**From:** Kathleen McDonald  
**Sent:** Wednesday, March 16, 2022 5:27 PM  
**To:** Kathleen McDonald  
**Subject:** RE: [EXTERNAL] Re: [EXTERNAL] Re: [EXTERNAL] Re: [EXTERNAL] Re: [EXTERNAL] 6 Fletchers Lane

**Subject:** [EXTERNAL] 6 Fletchers Lane

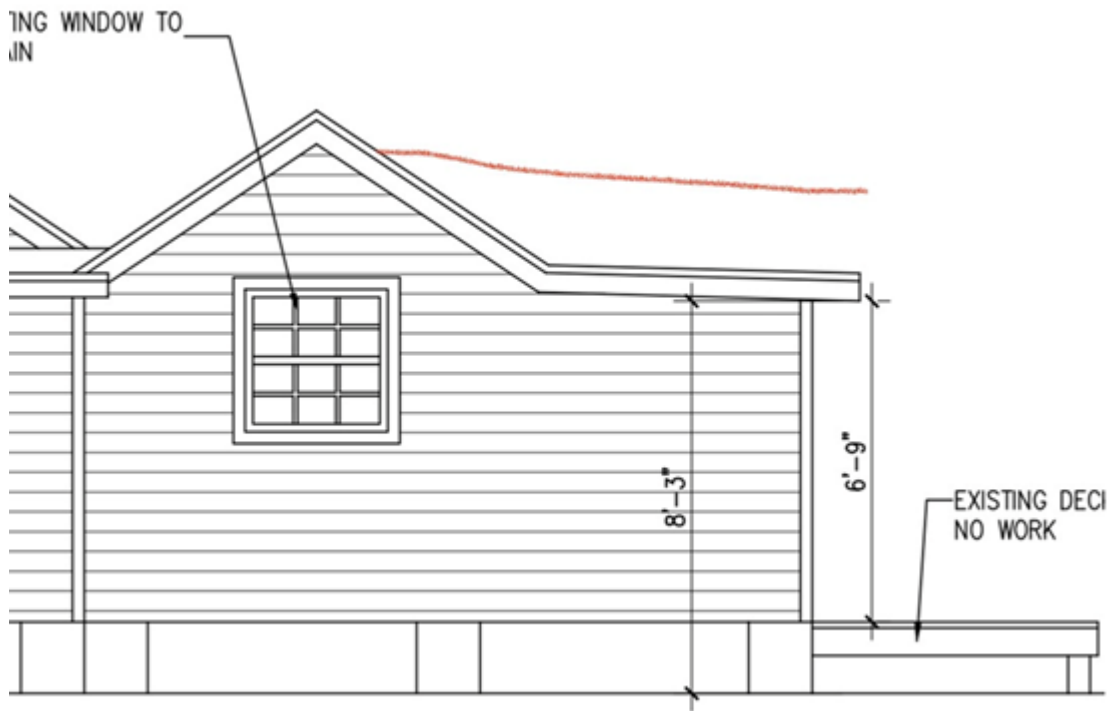
If the third sawtooth is not an option, I believe the next best option in terms of the HARC guidelines would be the below:

Though it is not the most ideal, as I previously wrote, it is more appropriate in comparison to the other options that were proposed. The proposal from your last email would again completely alter the roofing configuration of that historic sawtooth. Though the rear sawtooths are not identical, they are both historic.

If the homeowners would prefer to proceed with one of the alternate options that you proposed, they may present their case at the HARC meeting, but they would not receive a positive report from staff.

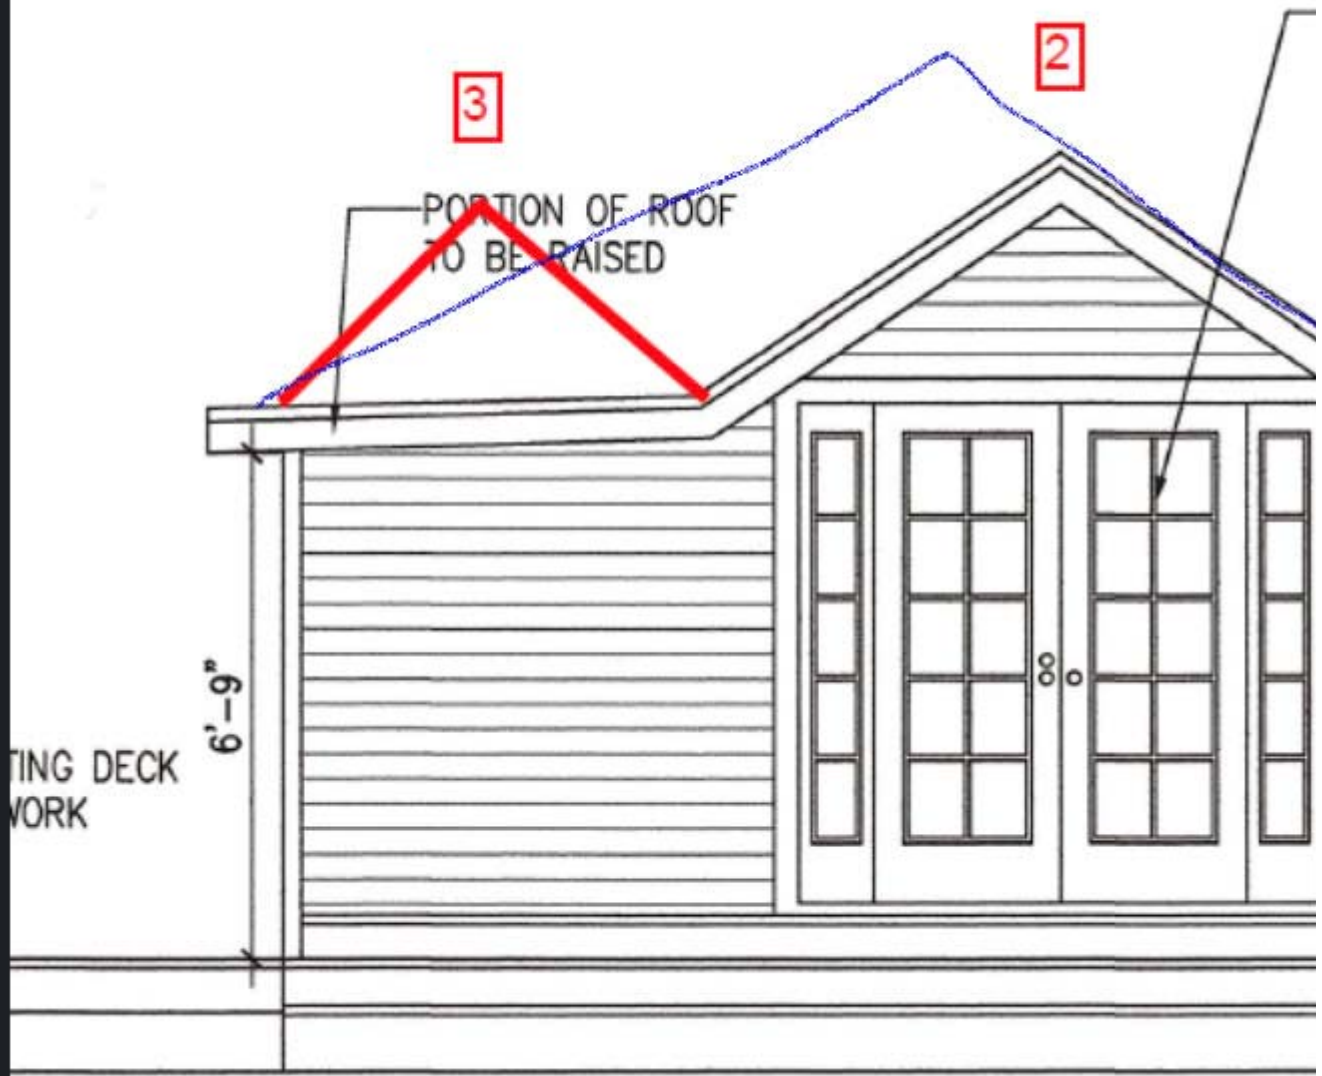
There is a concern that if we add another sawtooth, structurally we would have to add a support beam inside where the new sawtooth would start and it would defeat the purpose of this change altogether to raise the already very low interior ceiling.

Homeowners wanting to know if we made the existing sawtooth to be one larger proportioned one, would that be allowed. The rear two that are existing are not exact, not identical, neither in height or pitch.. see picture below with blue line.

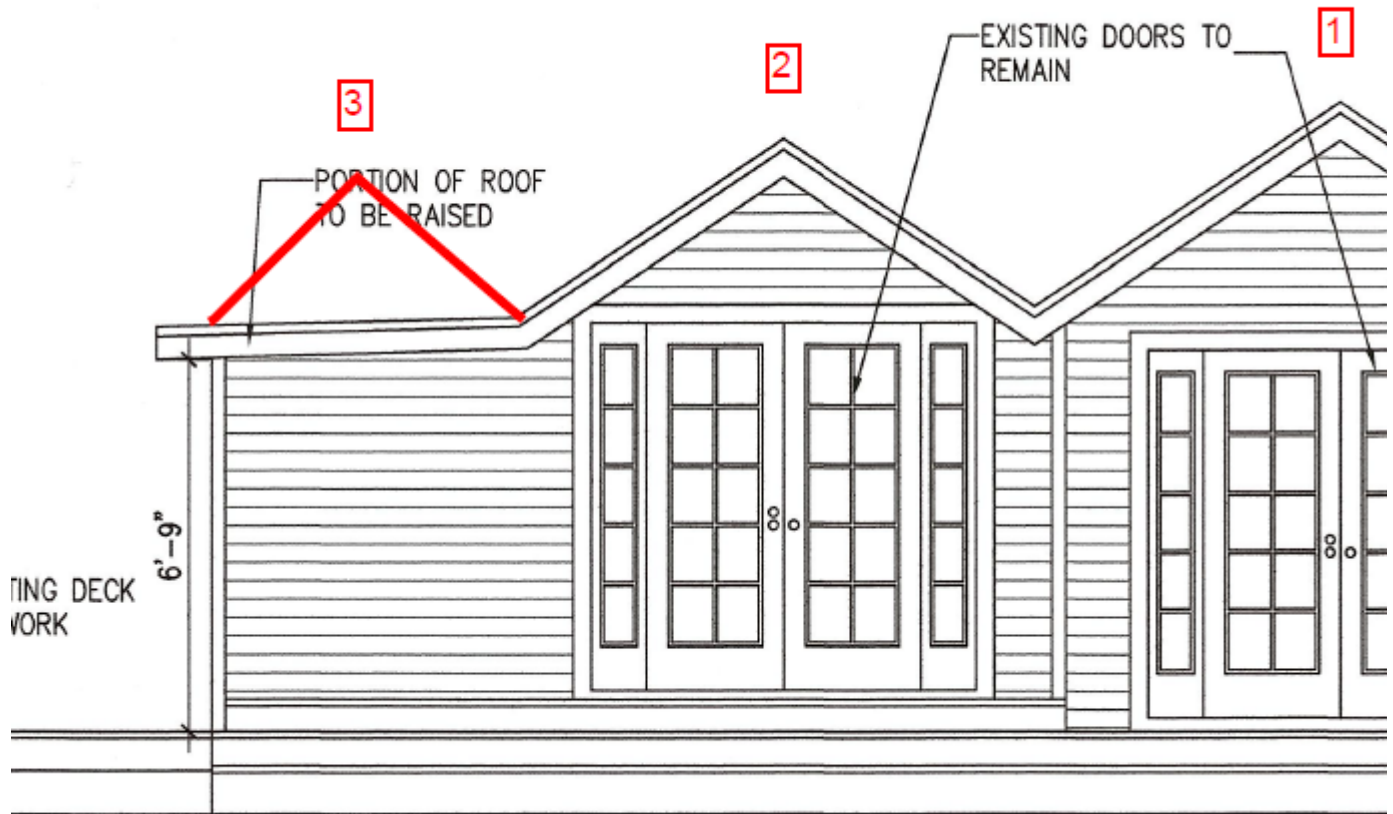
The 2<sup>nd</sup> option that you provided I explained in my previous email: “Coming in below the ridgeline with a new shed roof would be more typical, but you would still be partially concealing the original roofline of the historic sawtooth, which would still not be ideal. The goal would be to distinguish historic portions of the house from non-historic/new additions, and so the historic sawtooth should still be readable as its own element. Have you thought on the possibility of creating a third sawtooth with the new roofline? That would be the ideal option, which we could support as long as it’s proportioned correctly.” When I said “third sawtooth” I meant something similar to the below:

Have you thought on this possibility?

We had not thought of that as an option but after discussing with the homeowners they are fine with that design. I will revisit with engineer and send you a revised drawing to review.

WEST ELEVATION

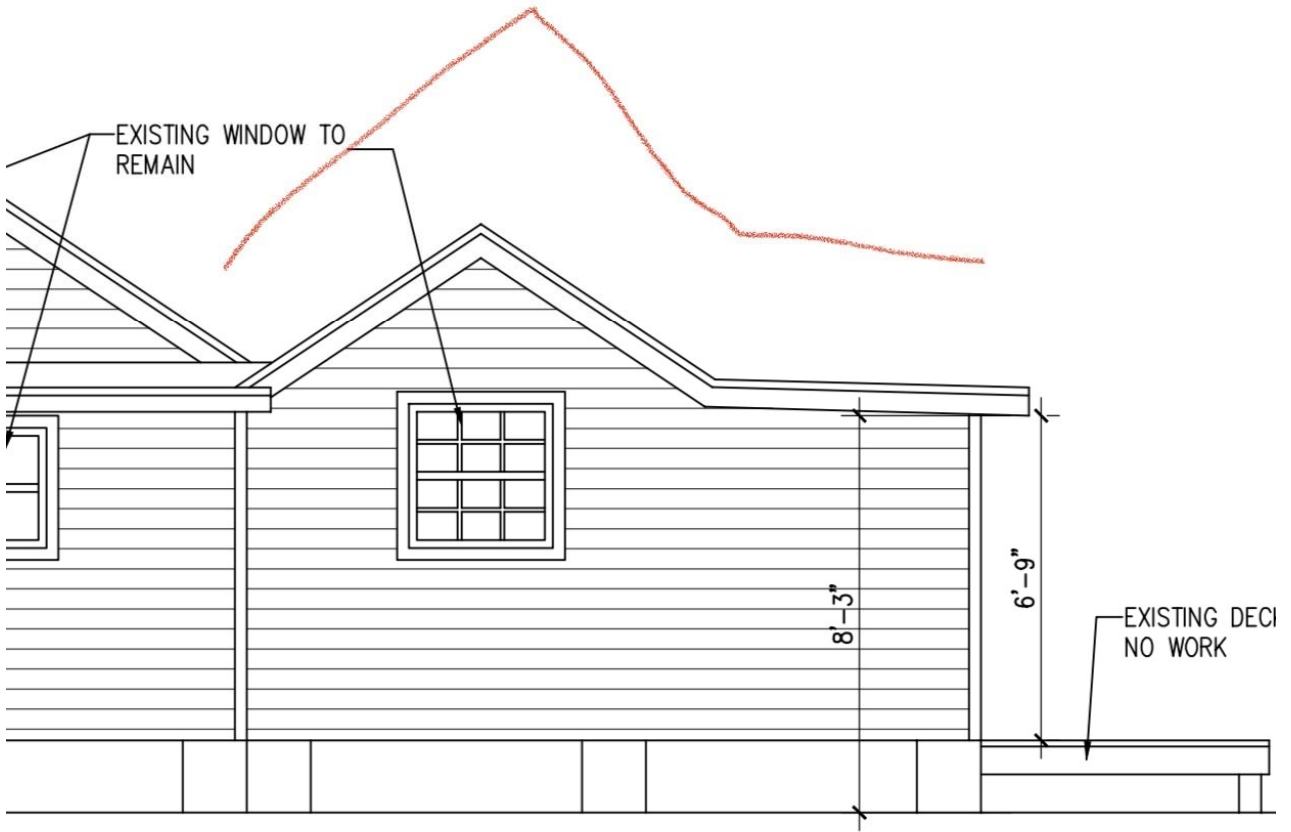
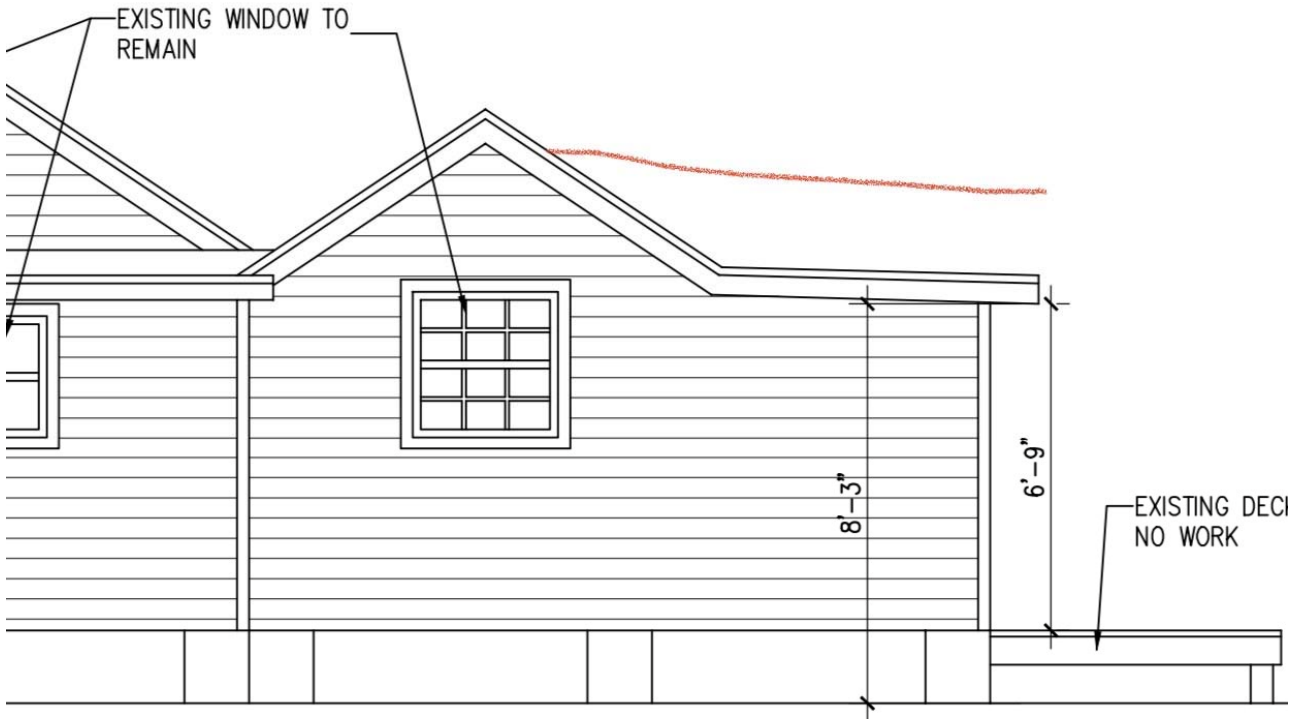
If we went with one of these options: could we not go to harc commission? Pictures below.

1.) Raise the ridge completely and sawtooth completely, leaving as is just higher.

2.) Put sawtooth slightly down from ridge.. 12",16"??

Any reconfiguration of the roof will require HARC Commission. The 1<sup>st</sup> option that you provided would not be supported by staff, as it would completely alter the roofing configuration by raising the historic sawtooth addition.
